Access Compliance Report

Public Rights-of-Way

(Curb Ramps)

Intersection ID: 32203	Main Street: CAMBRIDGE_GREEN_DR	Cross Street: KEW_GARDENS_LN	Location:	N
ADA ID: E68309200285	Ramp Type: PerpDiag	Initial Pass/Fail: Fail	Overall Compliance: No	Severity Score: 8.75
Codes/Mitigation Info/Possible Solution		Field Measurements/Component Compliance

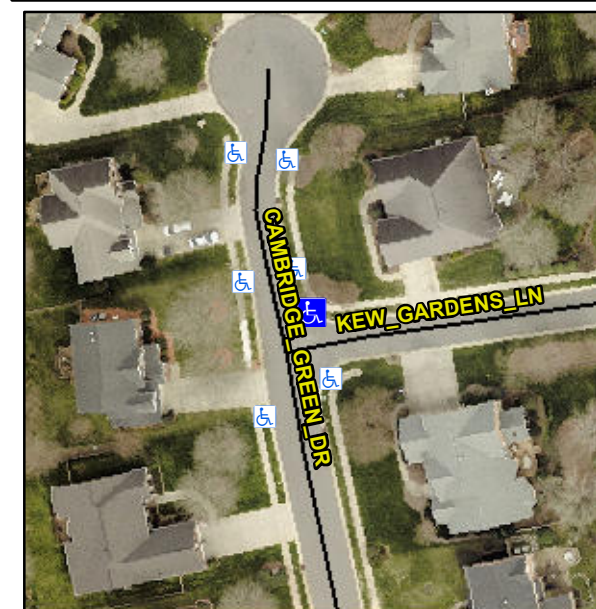
Compliance	Description	Data	Compliance	Description	Data
N/A	Ramp Length (in)	47.0	Yes	Ramp Slope (%)	6.4
No	Ramp Width (in)	42.0	Yes	Ramp XSlope (%)	1.1
N/A	Flare Type LT	N/A	N/A	Flare Type RT	N/A
N/A	Flare Slope LT (%)	N/A	N/A	Flare Slope RT (%)	N/A
N/A	Flare Traversable LT?	N/A	N/A	Flare Traversable RT?	N/A
N/A	Landing Length (in)	N/A	N/A	DWS Provided?	N/A
N/A	Landing Width (in)	N/A	N/A	DWS Contrast?	N/A
N/A	Landing Slope (%)	N/A	N/A	DWS Length (in)	N/A
N/A	Landing X Slope (%)	N/A	N/A	DWS Full Width?	N/A
N/A	Landing Curb? (Y/N)	N/A	N/A	DWS Offset (in)	N/A
N/A	Shared Landing?	N/A			
N/A	Gutter Ponding?	N/A	N/A	Gutter Slope (%)	N/A
N/A	Gutter Lip Ht (in)	N/A	N/A	Gutter X Slope (%)	N/A
N/A	Painted X Walk1?	No	N/A	Painted X Walk2?	No
	X Walk 1 Direction	To W		X Walk 2 Direction	To S
N/A	X Walk 1 Width (in)	N/A	N/A	X Walk 2 Width (in)	N/A
	X Walk 1 Slope (%)	0.2		X Walk 2 Slope (%)	2.8
	X Walk 1 X Slope (%)	3.2		X Walk 2 X Slope (%)	0.1

N/A	Ramp inside XWalk1?	N/A	N/A	Ramp inside XWalk2?	N/A
	Road Slope (%)	1.0	N/A	Clear Space?	N/A
	Road X Slope (%)	3.2	N/A	Clear Space to XWalk (in)	N/A
N/A	Any Obstructions?	N/A	N/A	Storm Grate/Utility Hazard?	N/A
	Obstruction Type			Storm Grate/Utility Type	
		N/A			N/A
			Yes	Surface Condition? (G/P)	Good

Remove & Replace Curb Ramp With Two New Directional Ramps or Equivalent.
